Office Action Summary	Application No. 10/830,220	Applicant(s) YOSHIDA ET AL.	
	Examiner Roberto Velez	Art Unit 2829

DETAILED ACTION

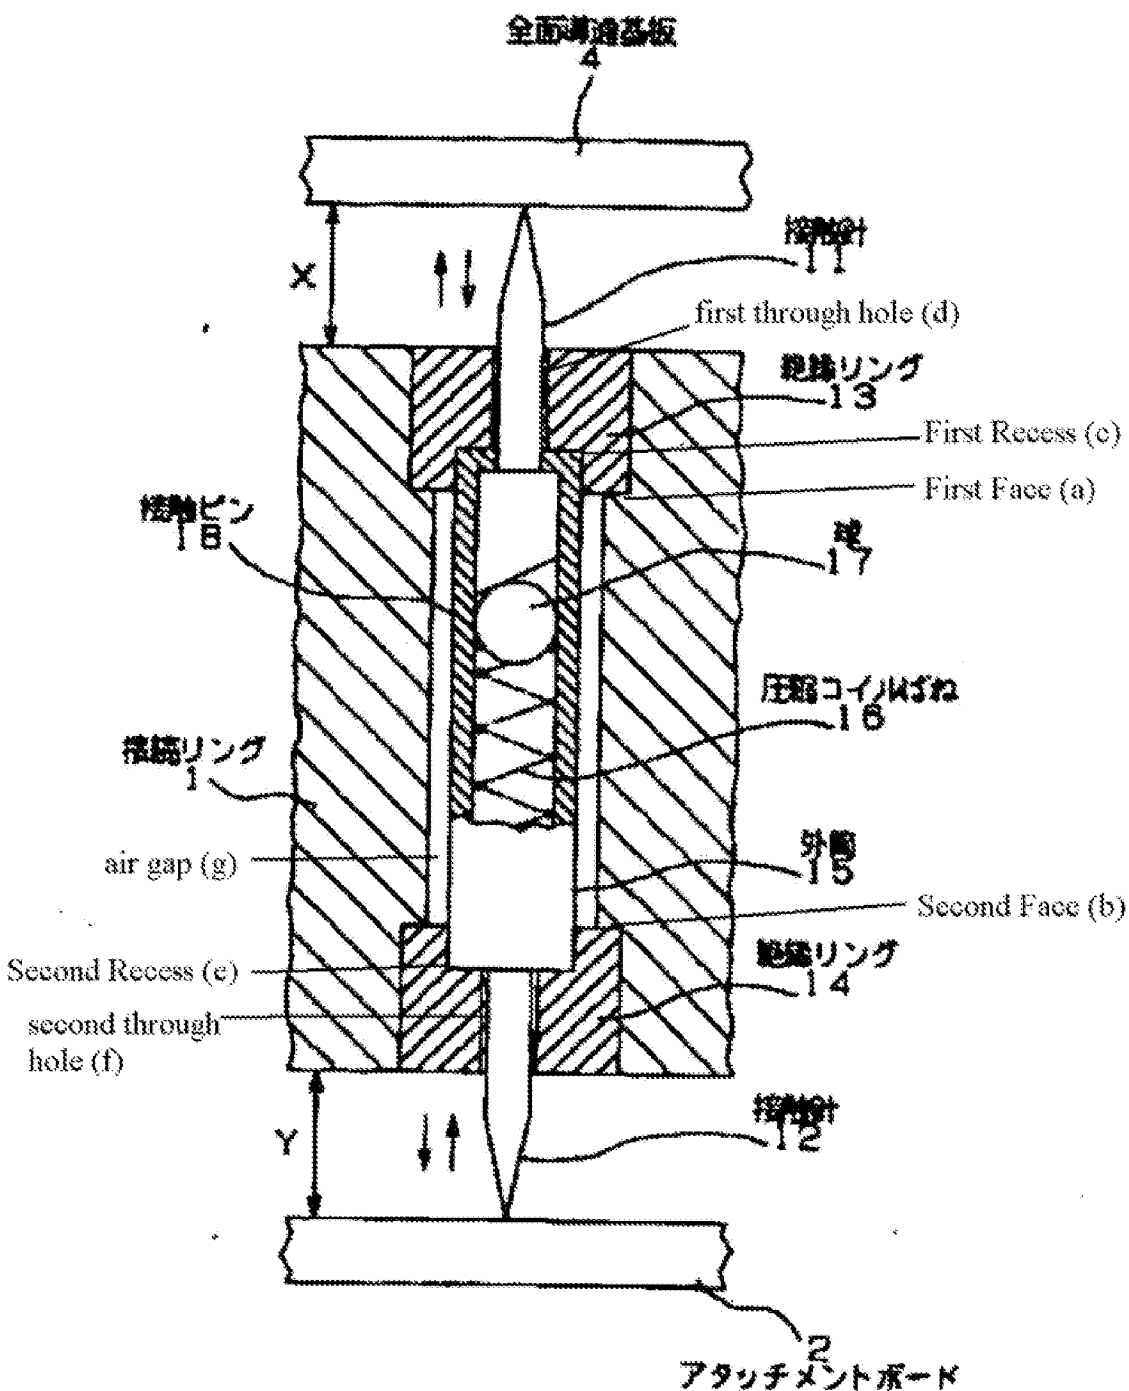
Regarding claim 1, JP 06-087874 shows (Figures 2-3) an inspection coaxial probe, comprising: a block [1], formed with a first face (a), a second face (b) opposed to the first face (a) and a penetration hole (formed between a and b) connecting the first face (a) and the second face (b); a contact probe [1B], comprising: a conductive pipe [15]; and a conductive plunger [11], retractably provided in at a first end of the pipe [15], and adapted to be brought into

contact with a device to be inspected; and a first insulative substrate [13], provided on the first face of the block and formed with a first recess (c) and a first through hole [d] communicated with the first recess [c], wherein the first end of the pipe [15] is fitted into the first recess [c] such that the contact probe [1B] is coaxially retained in the penetration hole and the first through hole [d] (as shown in Fig. 3) and a part of an outer periphery of the pipe [15] directly faces an interior wall of the penetration hole while forming an air gap [g] therebetween (as shown in Fig. 3).

JP 06-087874 fails to disclose a conductive block. However, Kasukabe et al. shows (Fig. 15a) a conductive block [217].

It would have been obvious to one of ordinary skill in the art at the time the invention was made to incorporate the teachings of Kasukabe et al. into the device of JP 06-087874 by having a conductive block. The ordinary artisan would have been motivated to modify JP 06-087874 in the manner set forth above for the purpose of acting as a shield to the probe while forming a coaxial arrangement.

Notes: For reference characters (a-g), please see drawing below. Also, it has been held that the recitation that an element is “adapted to” perform a function is not a positive limitation but only requires the ability to so perform. It does not constitute a limitation in any patentable sense. *In re Hutchison*, 69 USPQ 138.

Regarding claim 5, the combination of JP 06-087874 and Kasukabe et al. discloses everything as claimed above in claim 1; in addition, JP 06-087874 shows (Figures 2-3) a second insulative substrate [14], provided on the second face (b) of the block [1] and formed with a

second recess (e) and a second through hole (f) communicated with the second recess (e), wherein a second end of the pipe [15] is fitted into the second recess (e), such that the contact probe [1B] coaxially retained in the second through hole (f), wherein the contact probe [1B] is adapted to be electrically connected to a wiring board [30] on which an inspection circuit is provided via the second end of the pipe [15].

Notes: For reference characters (a-g), please see drawing above. Also, it has been held that the recitation that an element is “adapted to” perform a function is not a positive limitation but only requires the ability to so perform. It does not constitute a limitation in any patentable sense. *In re Hutchison*, 69 USPQ 138.
